Montgomery Planning  
**OLNEY THEATER CENTER**  
**SITE PLAN AMENDMENT NO. 82001022E AND**  
**FINAL FOREST CONSERVATION PLAN AMENDMENT**  
**NO. F2023004A**

Amendment to reconfigure the square footages of the approved theater buildings, modify the 10-foot-wide sidepath, install geothermal wells in the parking lot, reconfigure stormwater management facilities, and modify previously approved conditions.

No. 82001022E

November 9, 2023

*Figure 5. Vehicular and Pedestrian Circulations*

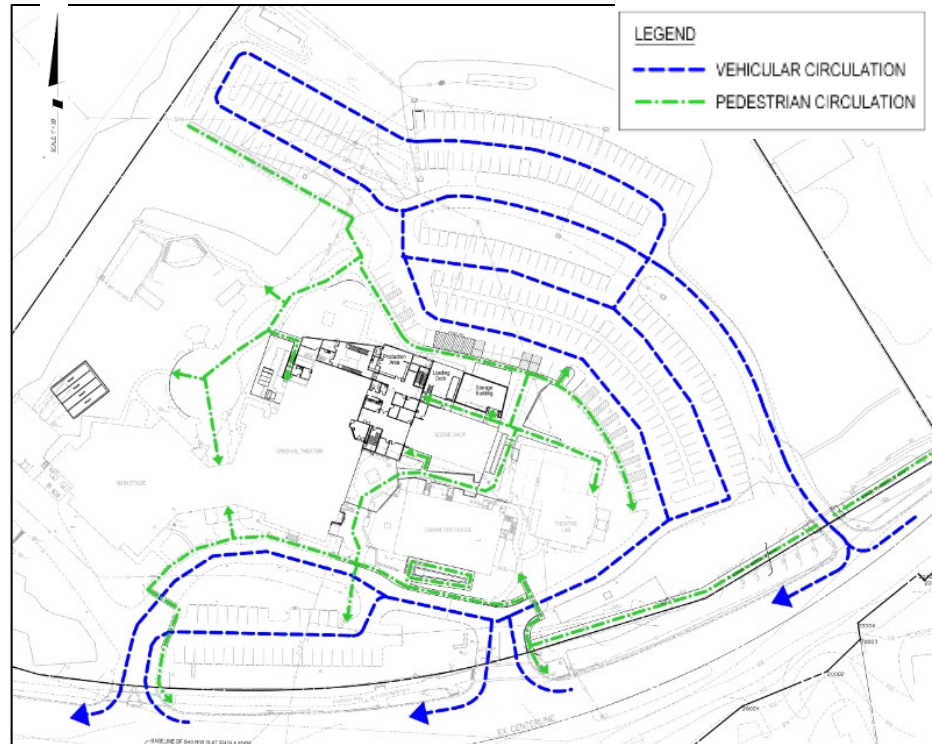
The Amendment will continue to provide a safe, adequate and efficient site access and circulation pattern on-site. The revisions proposed by this Amendment do not alter the placement of existing site access points or vehicular circulation patterns. Internal pedestrian access is adjusted slightly but not meaningfully altered from the prior approval and continues to be adequate (Figure 5).

Figure 9. Previously Approved 30% Design for Frontage Sidepath with Red Area to be Revised

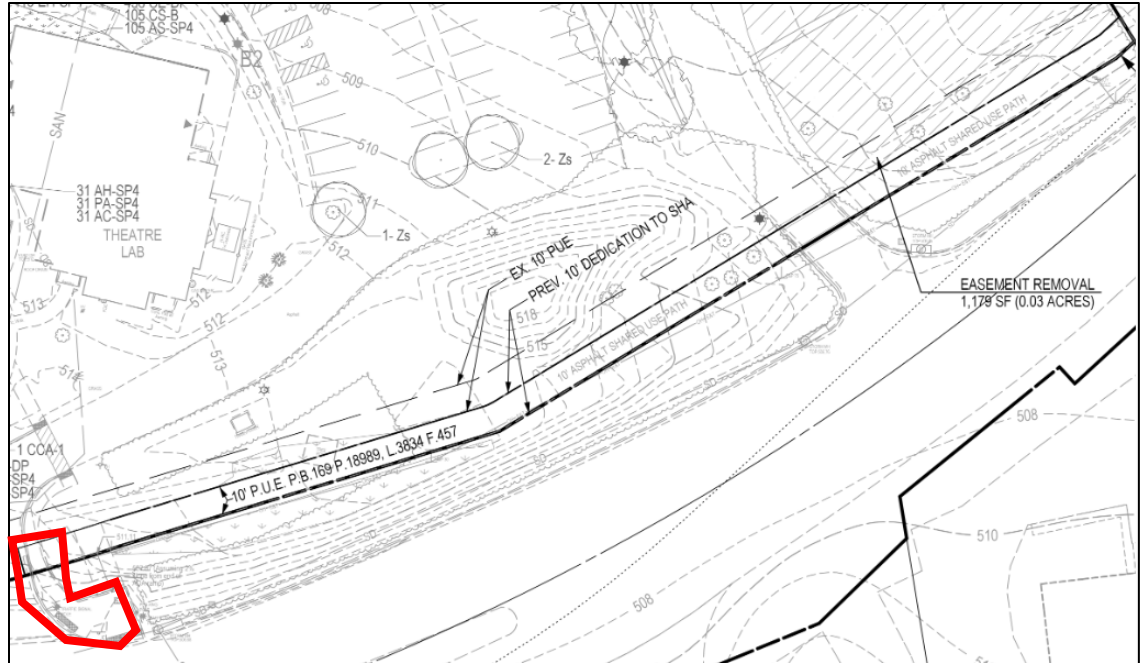
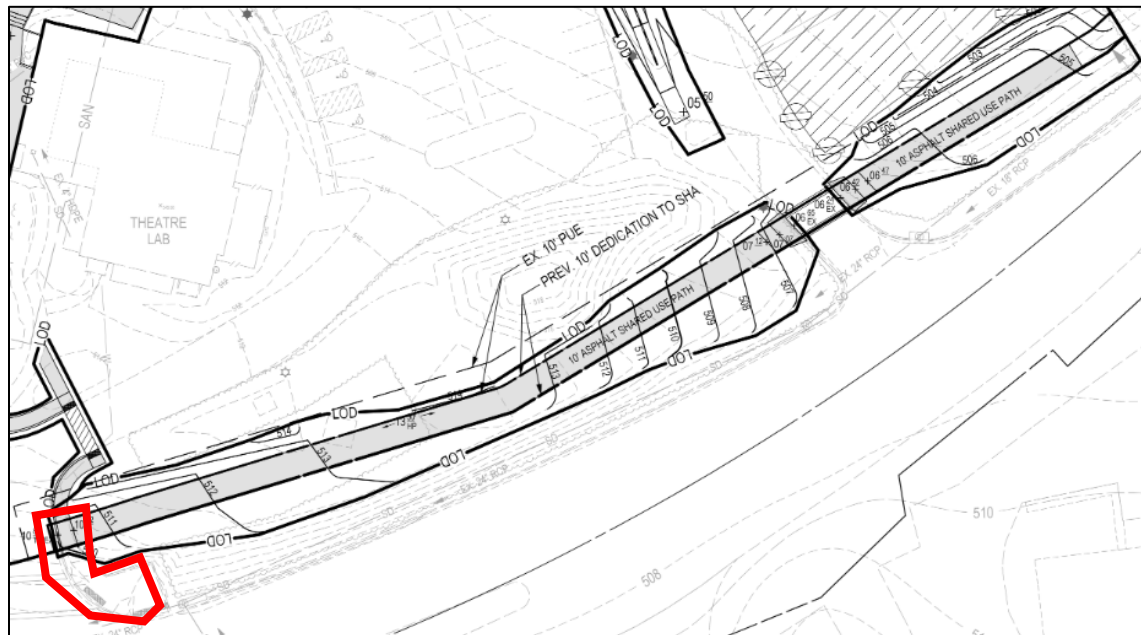
An existing 8-foot wide sidepath runs from the intersection of Dr. Bird Road to the western edge of the Property. This portion of frontage is not proposed to be altered with this Amendment, though future amendments may be required to improve the path to current standards. Instead, priority has been given to the portion of frontage to the east of the intersection, where an approximately 420 feet long, 10 feet wide new sidepath will be constructed. As conditioned in the C Amendment, 30% design plans were approved to provide an approximate alignment of this path, with the understanding that additional refinements may be necessary to finalize the design.

As conditioned with this Amendment, a small portion of the path is to be revised to address current standards. In particular, a stretch of approximately 15 feet of existing sidewalk is to be replaced with a 10-foot-wide asphalt sidepath. Additionally, the intersection landing area is to be expanded. This revision is necessary to accommodate safe, comfortable, and efficient bike movement from the intersection landing area to the path. The expansion of the path and landing area into the existing driveway will provide the secondary benefit of reducing the size of the driveway, which presently results in an uncomfortable 60-foot-wide crossing for bicyclists and pedestrians. This location additionally serves as an important junction with the terminus of the proposed Heritage Triangle bike system, which terminates at this location at the intersection of Dr. Bird Road. Without the conditioned revision, the reduced width would result in an uncomfortable and potentially hazardous biking condition that would jeopardize the utility and continuity of the bike system at large. This would additionally impose additional cost to the county as this deficiency would need to be addressed as part of the construction of these public projects.

- j) Revise the proposed sidepath to accommodate a continuous minimum width of 10 feet from the intersection of Doctor Bird Road to the eastern property line and improve the landing area of eastern side of the intersection to provide a minimum of 10 feet of clearance for both legs to accommodate bicycle movement. The design shall be approved by staff of Montgomery Planning and MDOT SHA.

*Figure 15 - Tree Variance Exhibit*

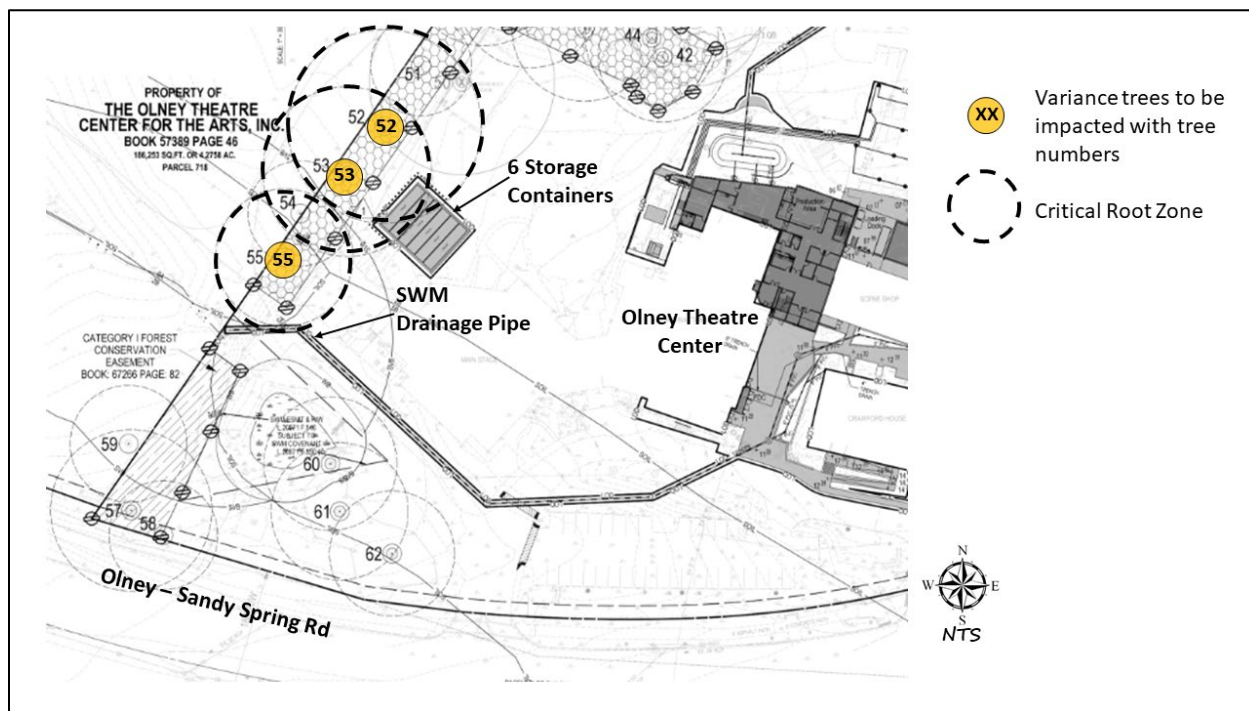
Three Protected Trees (Tree Nos. 52, 53 and 55) are being impacted by the limits-of-disturbance (“LOD”) for the project. The CRZs of Tree Nos. 52 and 53 are both impacted by the relocation of six storage containers. This relocation is necessary in order to create area for the new Loading Dock and Storage Building adjacent to the Scene Shop and to provide paved access to the containers from the existing drive on the west side of the Main Stage building. The CRZ of Tree No. 55 is being minimally impacted by the installation of a SWM drainage pipe which is directing storm water runoff from the theatre structures to the existing stream.

5. The Applicant must plant the variance tree mitigation plantings on the Subject Property with a minimum size of 3 caliper inches totaling 12 caliper inches as shown on the approved FFCP. Adjustments to the planting locations of these trees is permitted with the approval of the M-NCPPC Forest Conservation Inspection Staff.
